postal	Private Bag X6546, GEORGE, 6530
physical	4 <sup>th</sup> Floor York Park Building, York Street, GEORGE, 6530
website	<a href="http://www.capenature.co.za">www.capenature.co.za</a>
enquiries	<b>Mr. BA Walton</b>
tel.	+27 44 802 5300
fax	+27 44 802 5313
fax2email	+27 86 645 2546
email	<a href="mailto:landusegeorge@capenature.co.za">landusegeorge@capenature.co.za</a>
SSD ref. #	<b>14/2/6/1/6/1_BITO/305/16_2012/097</b>
date	<b>6<sup>th</sup> of August 2012</b>

### **APPLICATION IN TERMS OF THE NEMA EIA REGULATIONS FOR THE PROPOSED CHANGE OF LAND USE BY CONSTRUCTION AND INSTALLATION OF A 66 kV TRANSMISSION LINE FROM EXISTING ROBERG SUBSTATION ALONG ROUTE B TO PROPOSED SUBSTATION ON FARM No. 305 PORTION 16 AT SITE C, PLETTENBERG BAY, BITOU RIVER**

**DEA # 14/12/16/3/3/1/570**  
**DEA # 12/12/20/691**  
**NEAS # DEA/EIA/0001209/2012**

Figure 1: showing the Critical Biodiversity Area conservation network at the Bietou River Estuary, with the extent of the estuarine functional zone shown with a blue boundary.

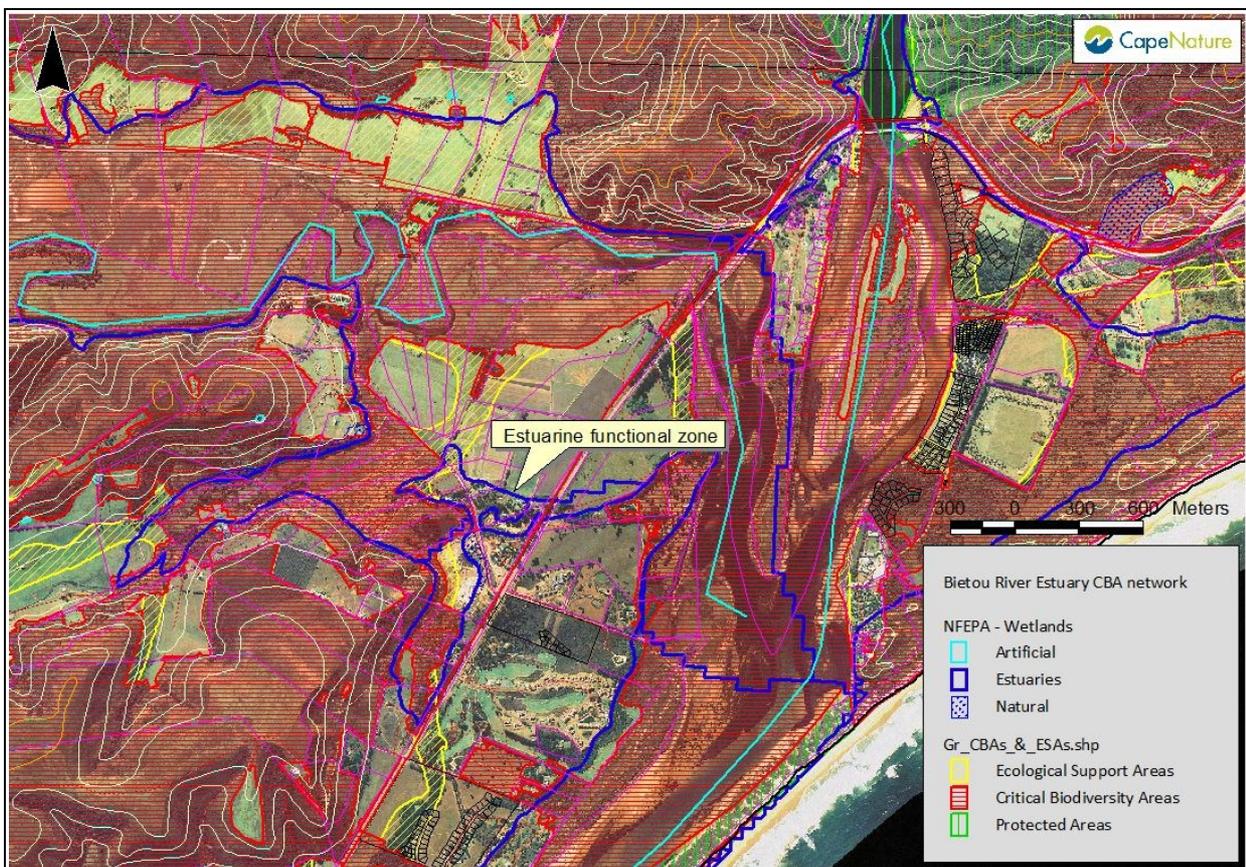
Selected remaining areas of natural vegetation and habitat have been designated as either: declared Protected Areas; Critical Biodiversity Areas<sup>3</sup> or Ecological Support Areas, as habitat required as part of the CBA conservation network; in addition to Other Natural Areas. Most of the remaining natural habitat here is a designated **Critical Biodiversity Area** and / or **Ecological Support Area** (see Fig. 1), selected for various criteria.

4. The National Freshwater Ecosystem Priority Areas (“NFEPA”) project has identified strategic spatial priorities for conserving South Africa’s freshwater ecosystems and supporting sustainable use of water resources. The linear development proposal traverses, and is situated within three designated River FEPA’s and associated sub-quatarnary catchment areas, draining towards the *Largely Natural* Bietou River (Present Ecological Status: Class B) or *Largely Natural* Keurbooms River Estuary (PES: Class B). The proposed linear development is also within the estuarine functional zone of the Bietou River Estuary, and within 100 metres of the High Water Mark of the sea (Coastal Public Property zone), which includes rivers with a tidal influence.

5. CapeNature will not support the loss of any threatened ecosystems, neither the transformation of identified sensitive areas (CBA’s / ESA’s / NFEPA’s); and nor incompatible land uses for biodiversity conservation objectives. CapeNature does not usually support development within the estuarine functional zone or within a highly sensitive area coastal area. It is however acknowledged that the 66 kV transmission line and associated substation are required to service development north of the Bietou River; and a limited form of infrastructural installation is permissible within designated sensitive areas based on regional need.
